**TOWN OF MOUNTAIN VILLAGE  
REGULAR DESIGN REVIEW BOARD MEETING AGENDA  
THURSDAY NOVEMBER 3<sup>RD</sup>, 2022 10:00 AM  
MOUNTAIN VILLAGE TOWN HALL  
455 MOUNTAIN VILLAGE BLVD, MOUNTAIN VILLAGE, COLORADO  
TO BE HELD HYBRID THROUGH ZOOM:**

**DESIGN REVIEW BOARD MINUTES  
TOWN OF MOUNTAIN VILLAGE REGULAR  
DESIGN REVIEW BOARD MEETING  
OCTOBER 6<sup>TH</sup>, 2022**

**SITE PLAN**  
 3/32" = 1'-0"

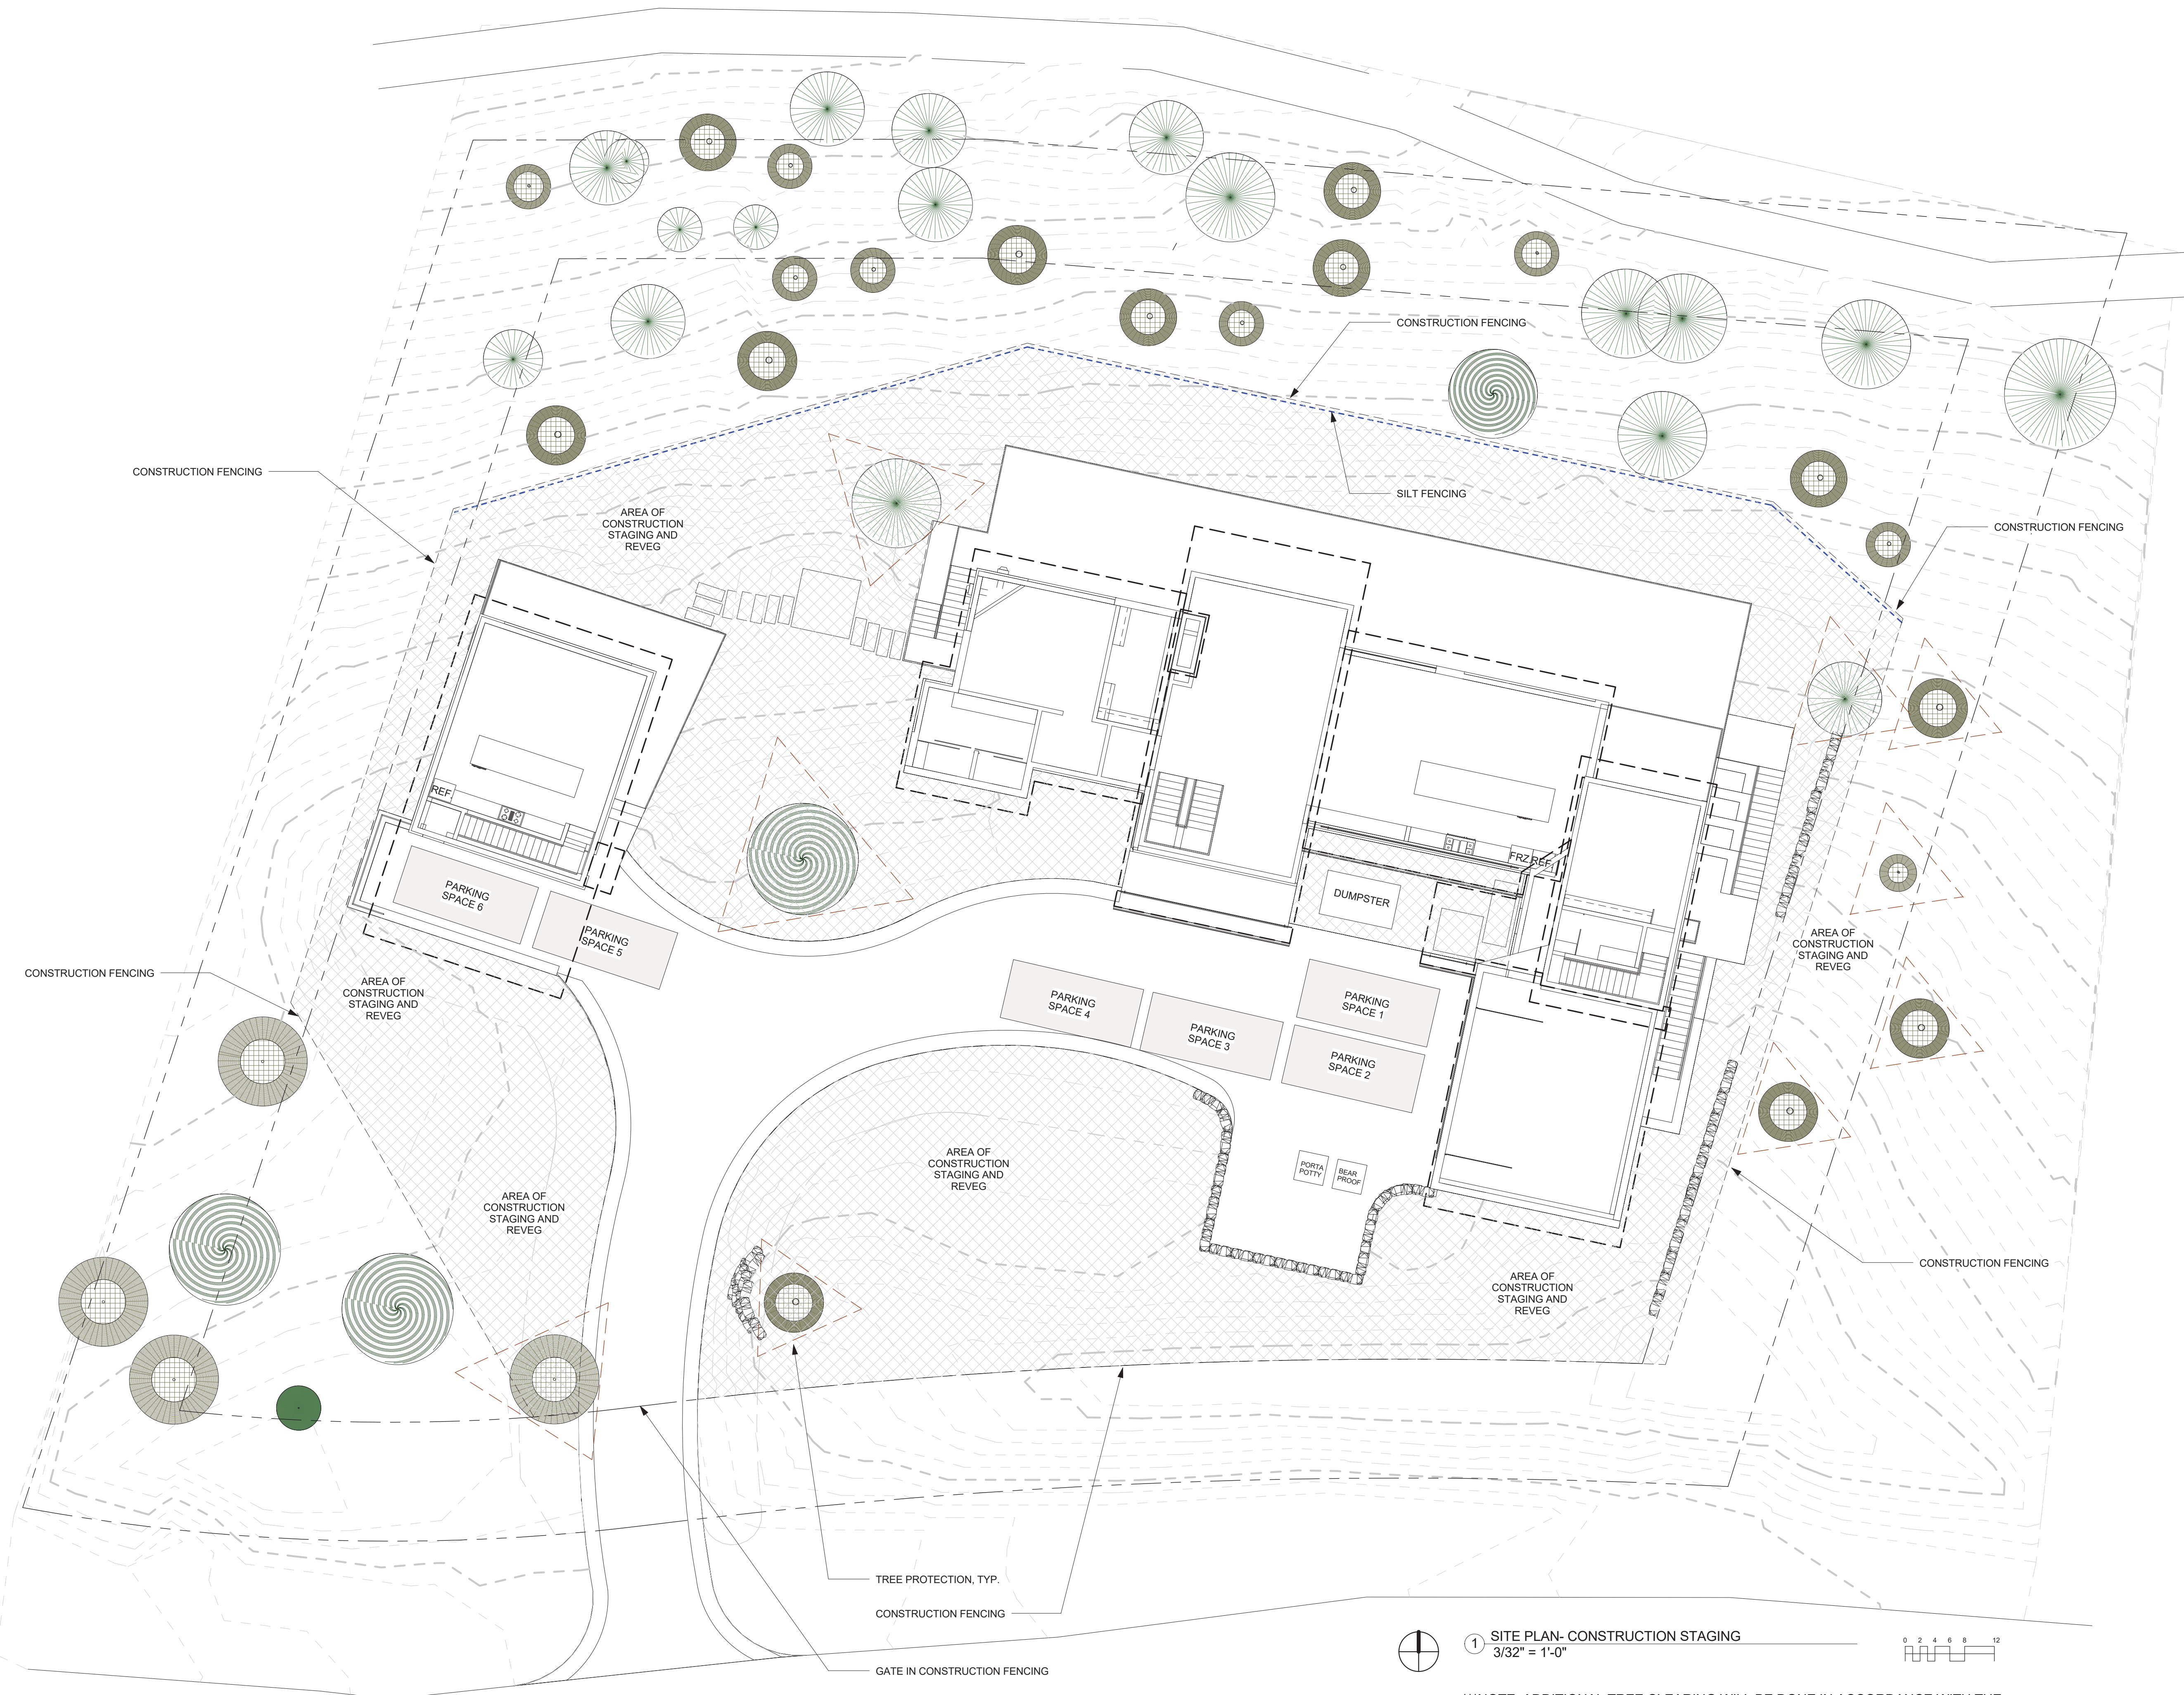
*Staff: Sheet A102 of Exhibit A shows the proposed Fire Mitigation Plan. The applicant has identified an "Outer Edge of Developed Area" which includes vegetation adjacent to the proposed development structures. Off of the "Outer Edge of Developed Area" the applicant has included the 15' Zone 1 Fire Mitigation area. The applicant has indicated the edge of dripline to surround the Outer Edge of Developed Area on the Landscape & Irrigation Plan on Sheet A103. Staff finds criteria to be met.*

1 SITE PLAN- CONSTRUCTION STAGING  
3/32" = 1'-0"

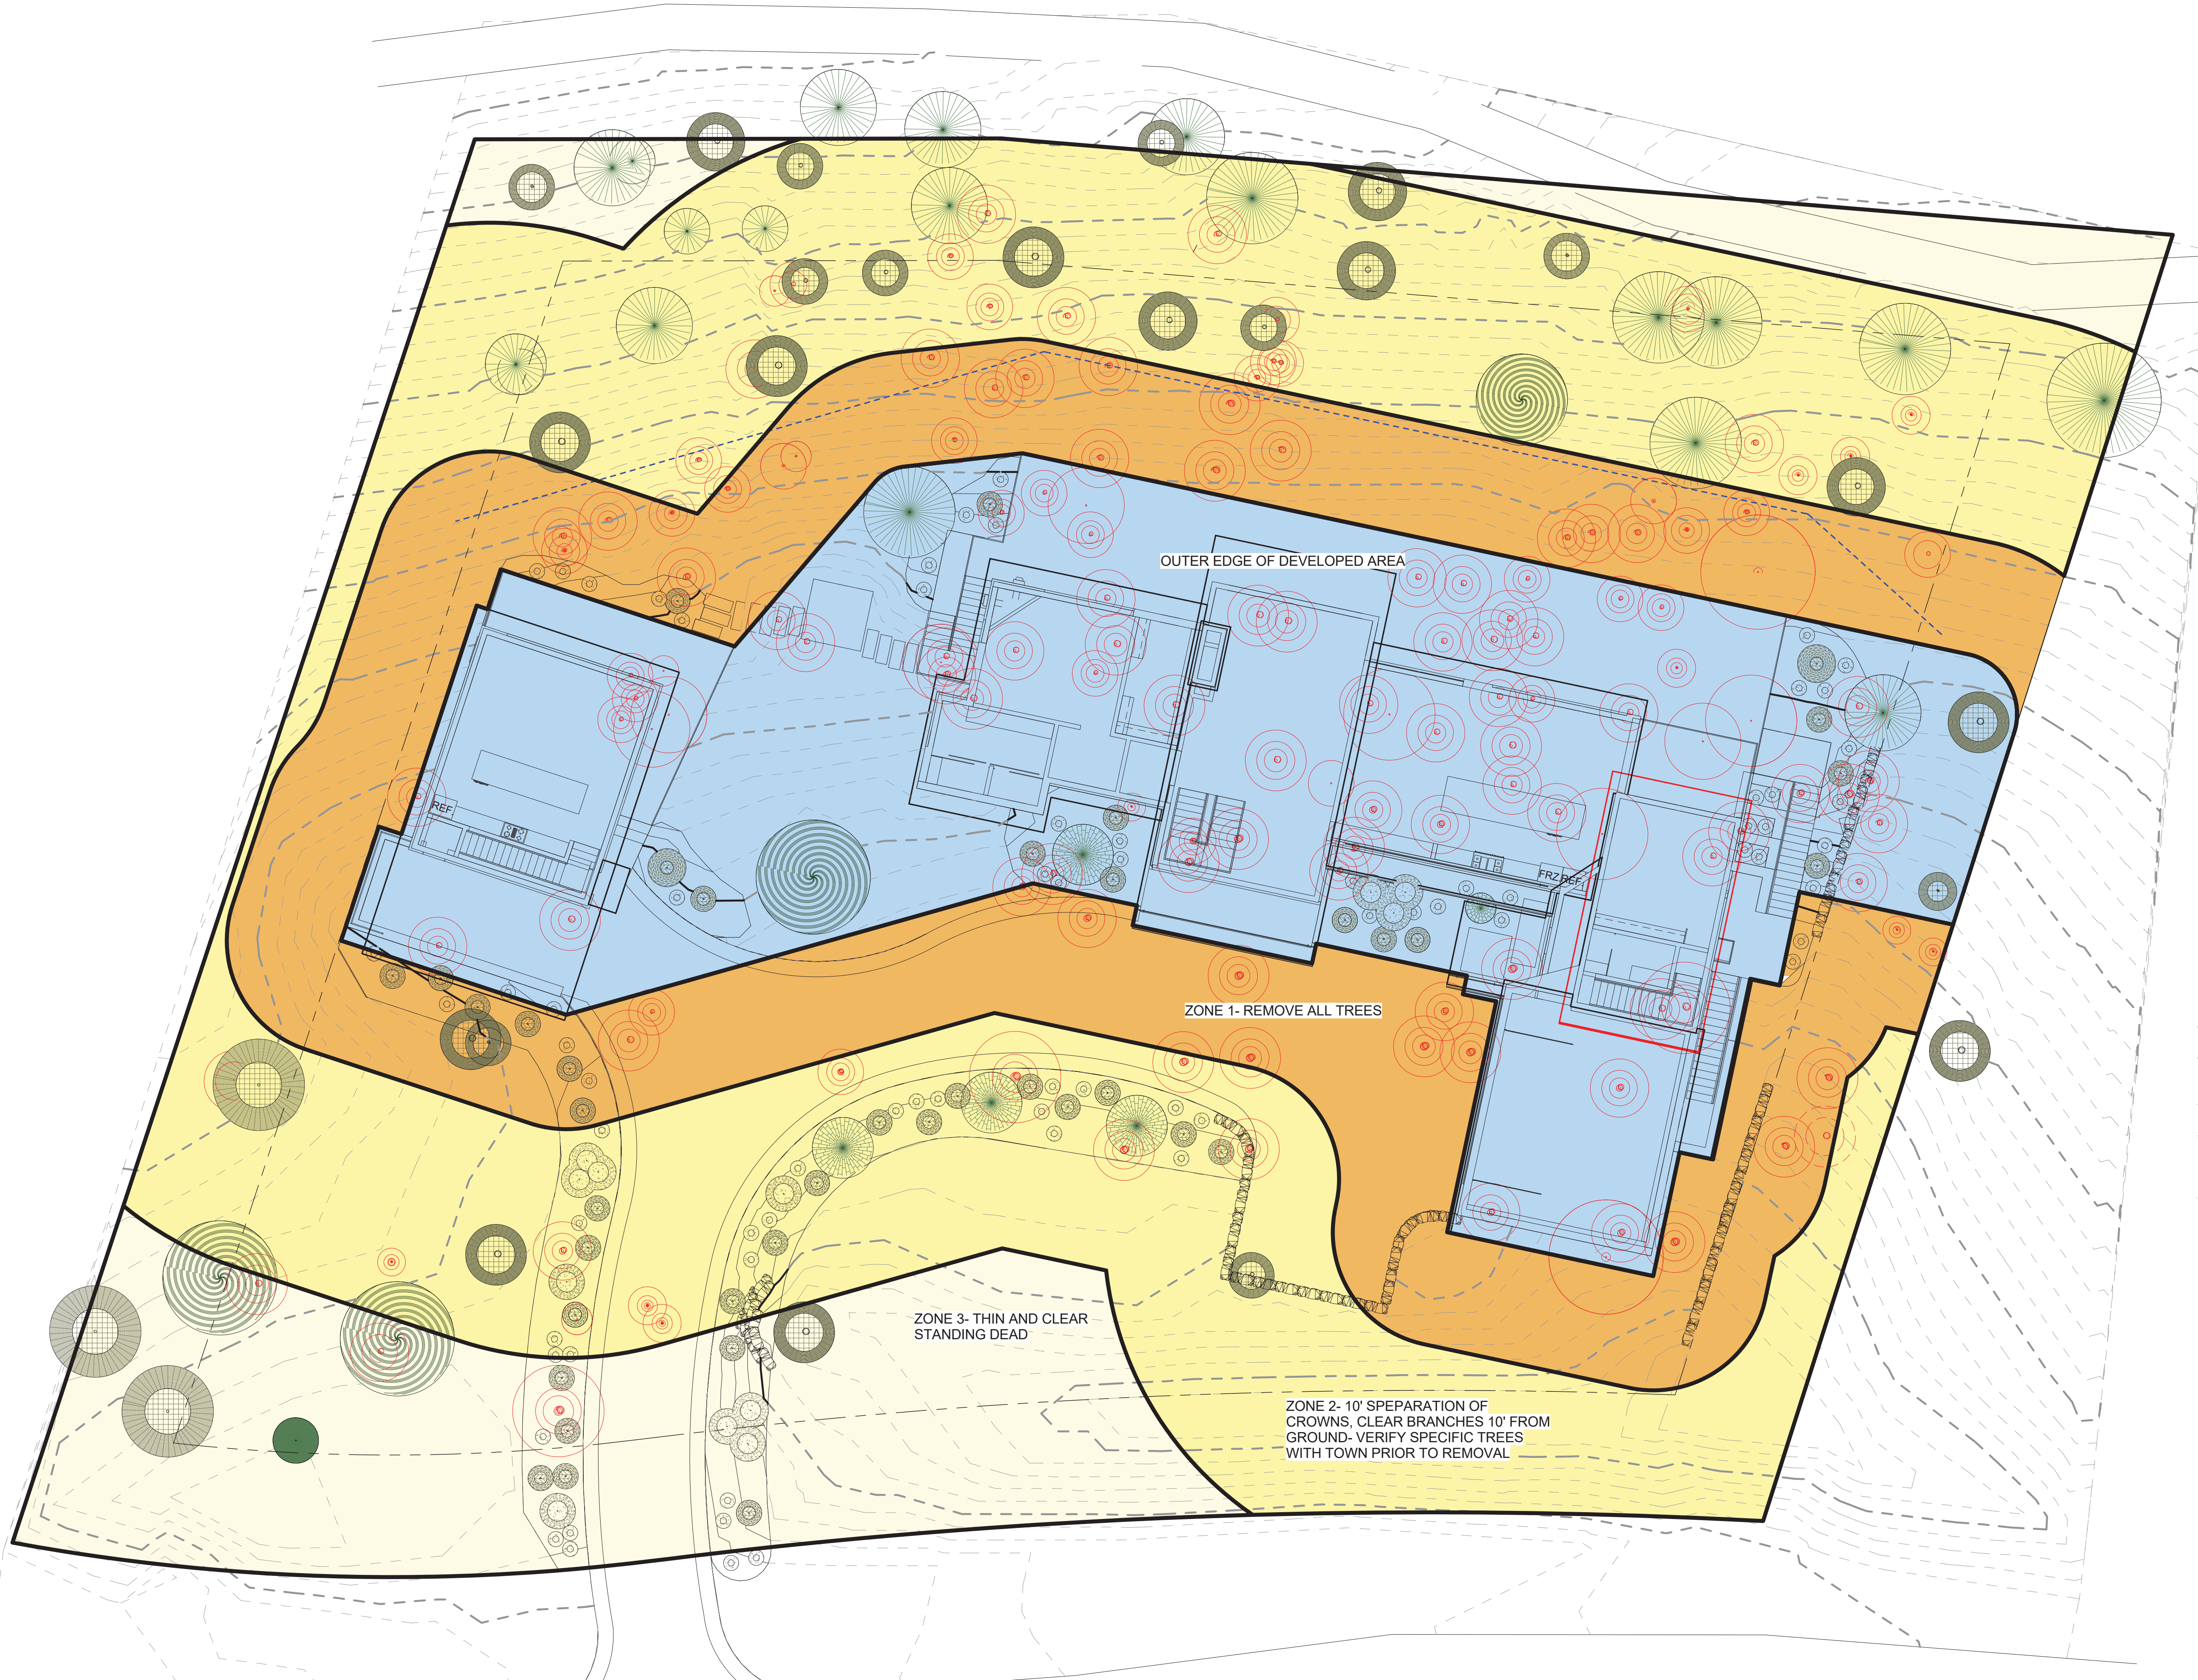
*Staff: The construction mitigation plan on Sheet A101 of Exhibit A has been updated to show protective fencing made of plywood shield and stakes to be erected in a triangular shape around existing trees. The plan has been updated to show one exterior area and one interior area to be used for storing materials.*

PROJECT NAME: 508 MV MOUNTAIN VILLAGE  
COLORADO 81435  
SHEET DESCRIPTION: EXTERIOR LIGHTING PLAN  
SHEET NUMBER: A104

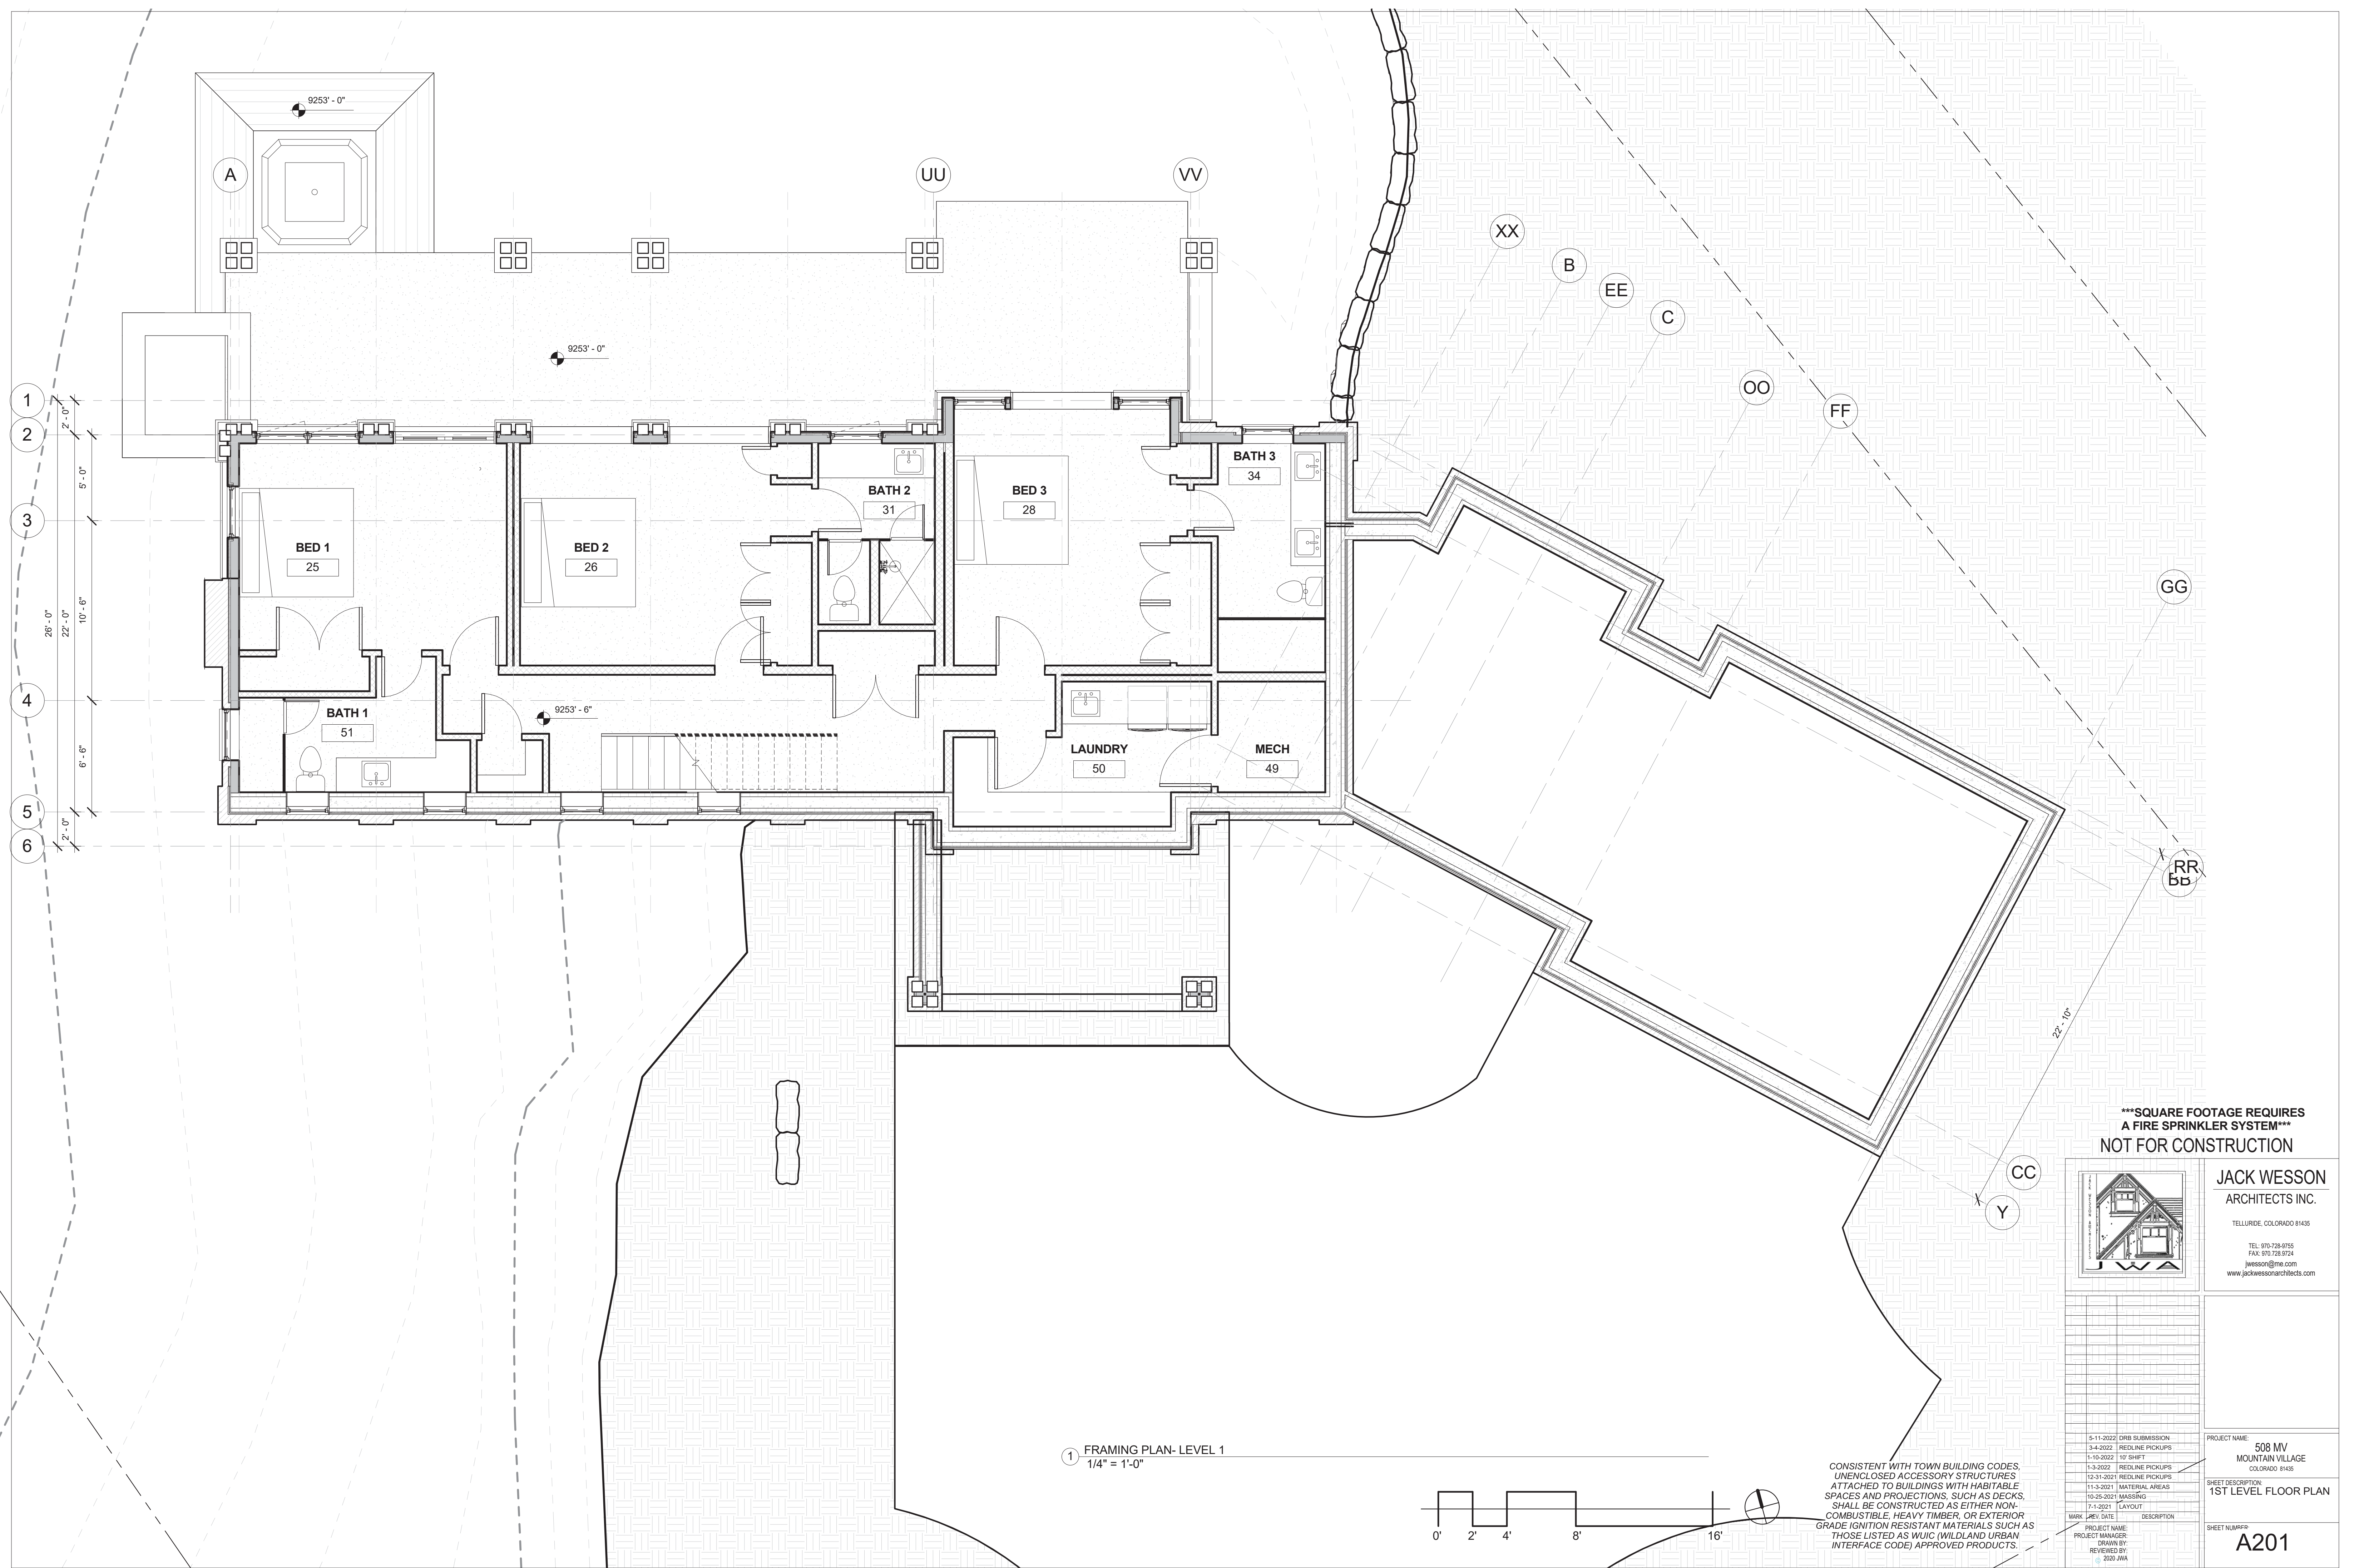
- A: LARGE EXTERIOR SCONCE: see cut sheet A810
- B: SMALL EXTERIOR SCONCE: see cut sheet A810
- C: EXTERIOR STEP LIGHT: see cut sheet A810
- D: EXTERIOR ROPE LIGHT: see cut sheet A810
